MOUNTAIN CREEK
Flood Protection Plan

City of Grand Prairie

MOUNTAIN CREEK FLOOD PROTECTION PLAN

January 16, 2009
FINAL

Figure 6: Alternative Planning Areas

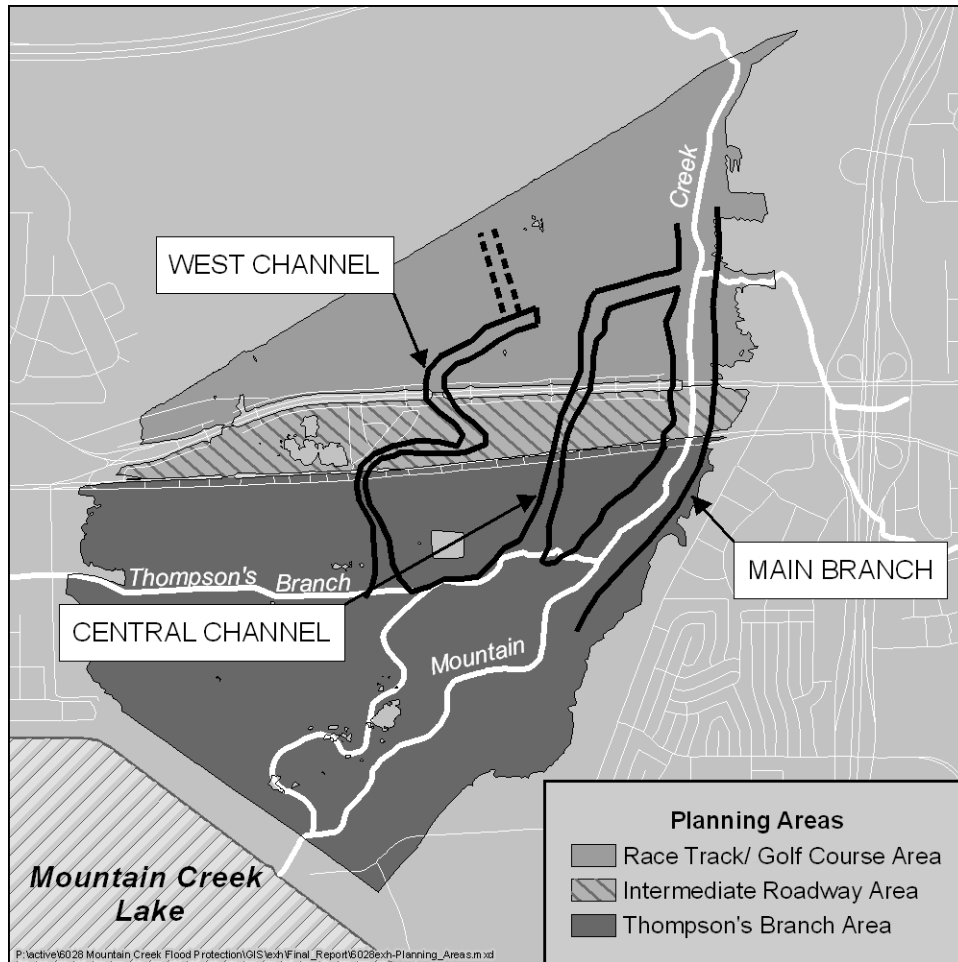
Comment: 1. Page 23, Figure 5 - Suggestion - Label location of Thompson's Branch

EXHIBIT #5
HEC-RAS CROSS-SECTION LOCATION MAP
MOUNTAIN CREEK FLOOD PROTECTION PLAN
GRAND PRAIRIE, TEXAS

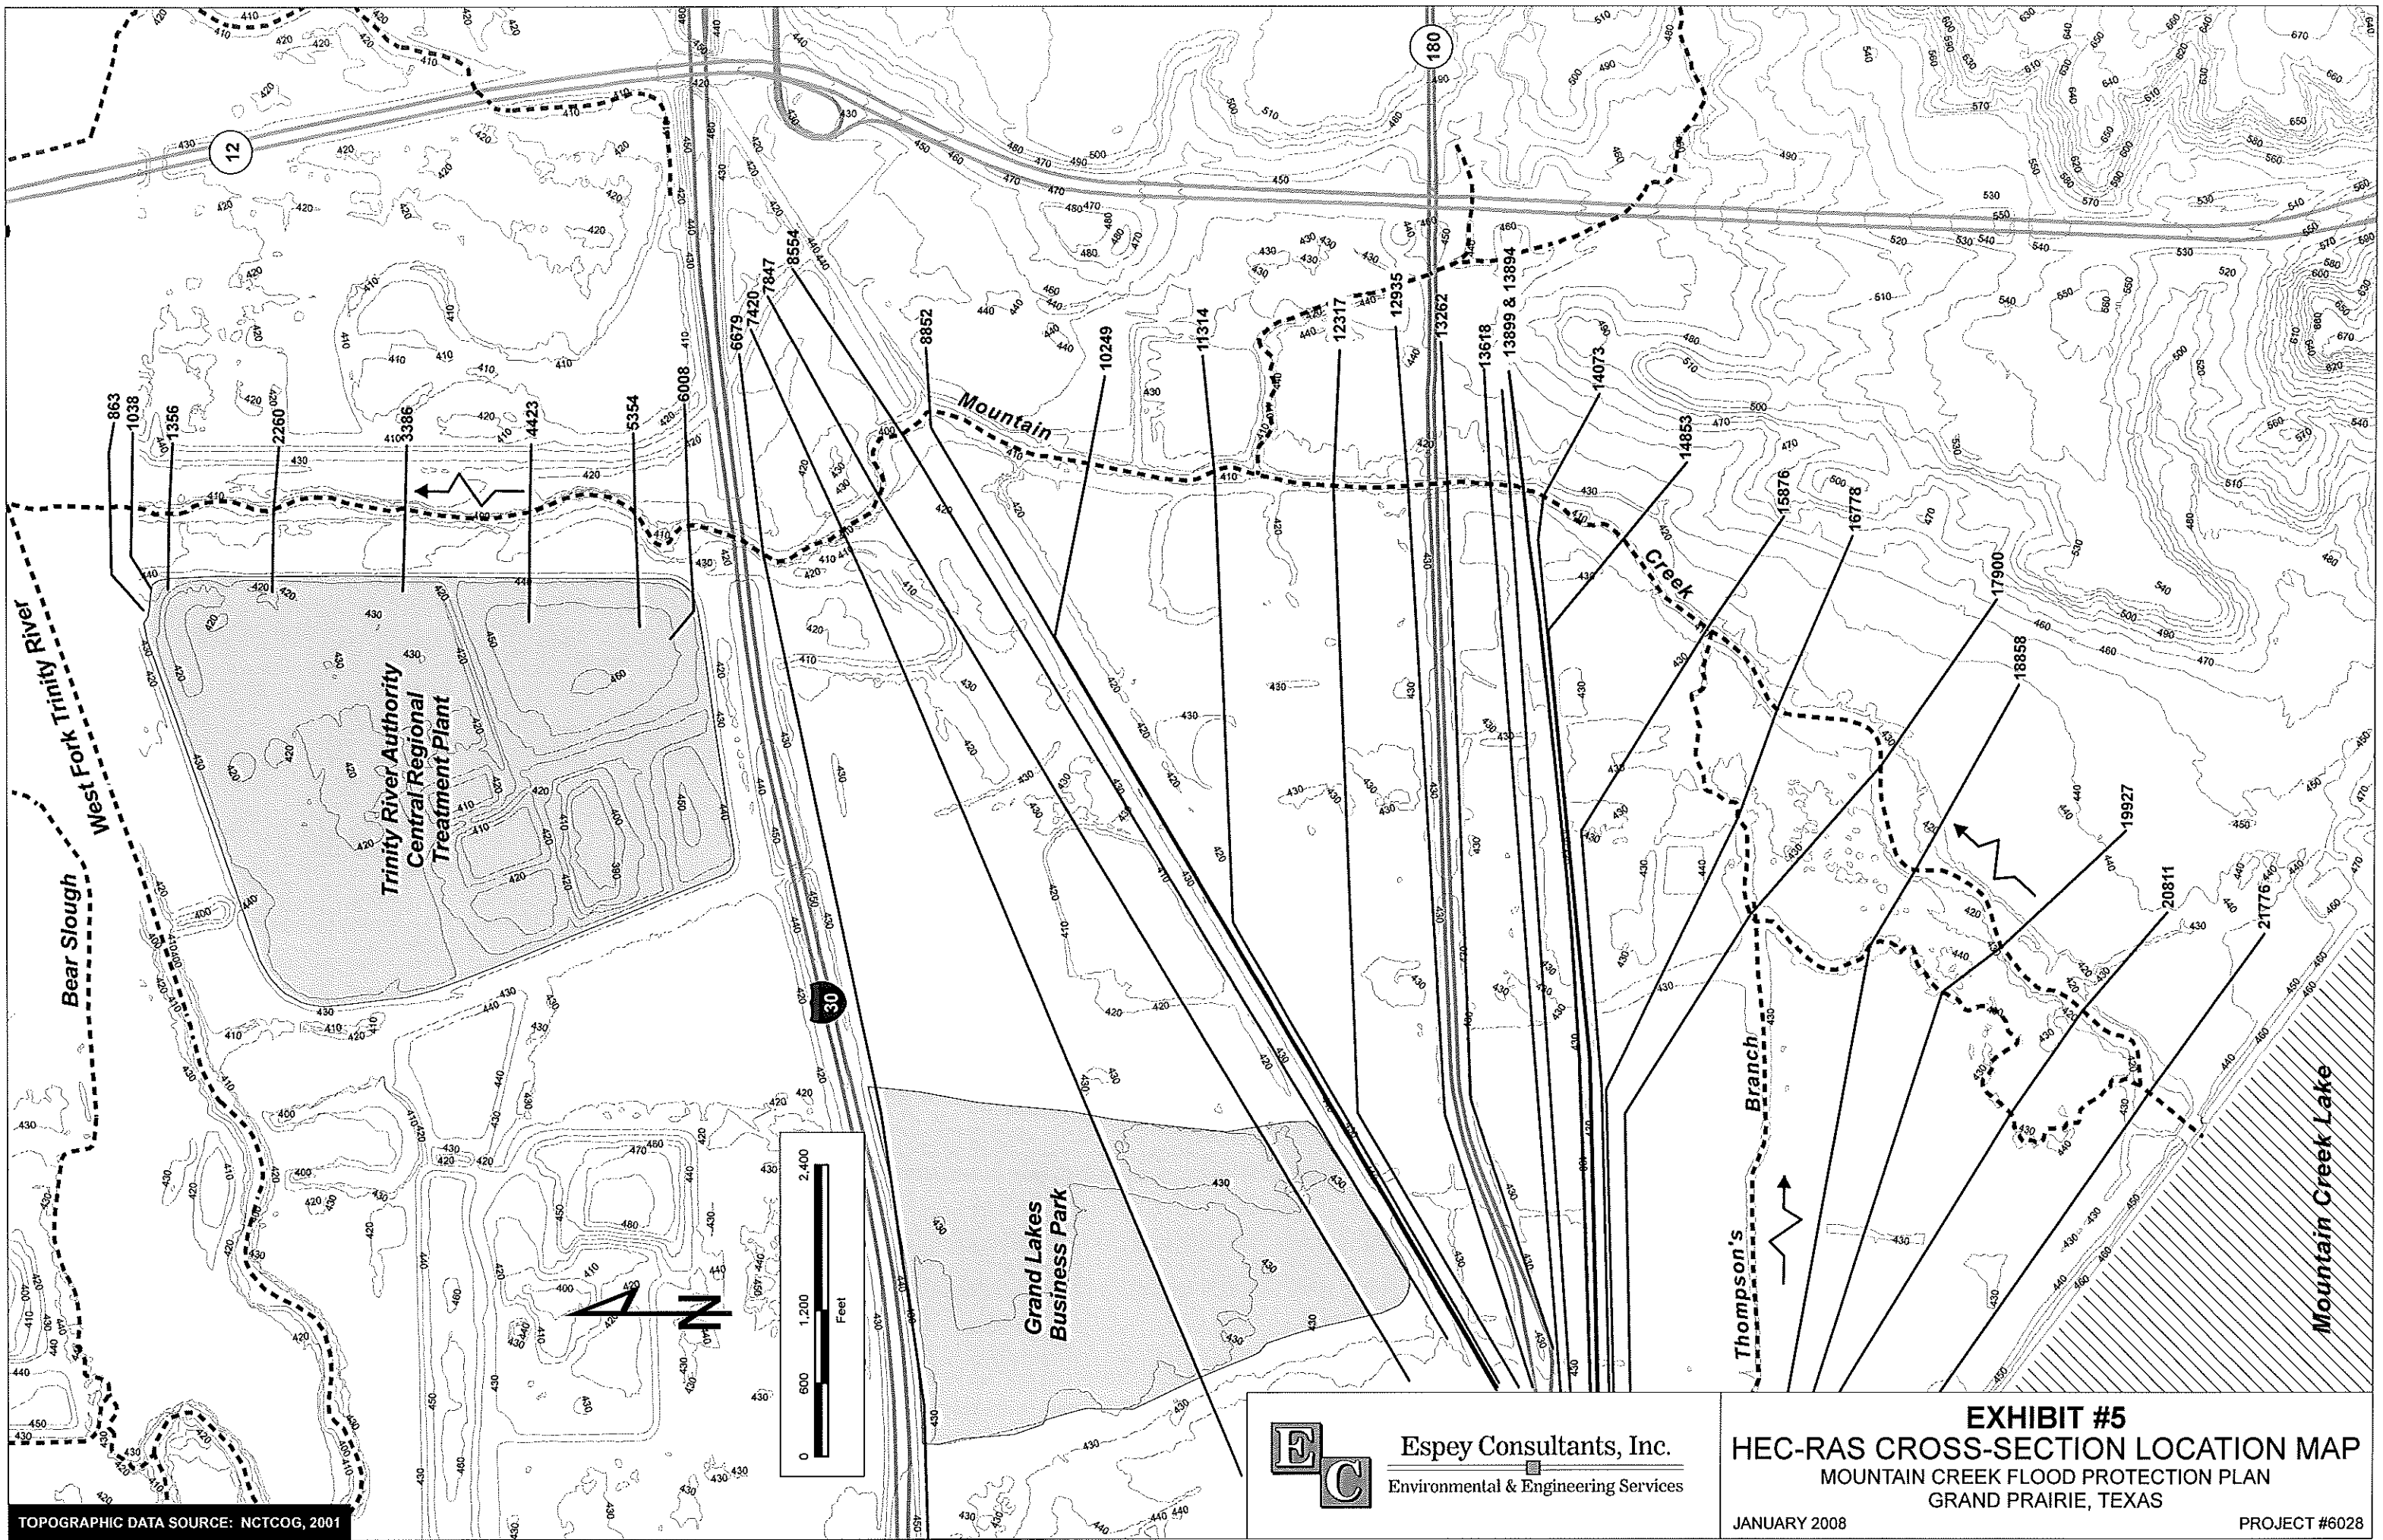
Comment: 2. Exhibit 5, Appendix A - Cross Section Location Map - If possible, label major contours and include the source of contours and date; suggestion would be to show centerline stationing and flow direction along Mountain and Thompson's branch; show cross-section 7420 (included in models, but not shown on map); suggestion would be to use a typical engineering scale drawing and make this scale consistent with other Exhibits (6, 7, 8)...possibly change this scale to 1"=1200' to match the others or include other, full-size plots in this report. The reason for this suggestion is so when this study is looked at in the future, distances can be measured more easily between the cross-section location map and flood maps (if separate maps)
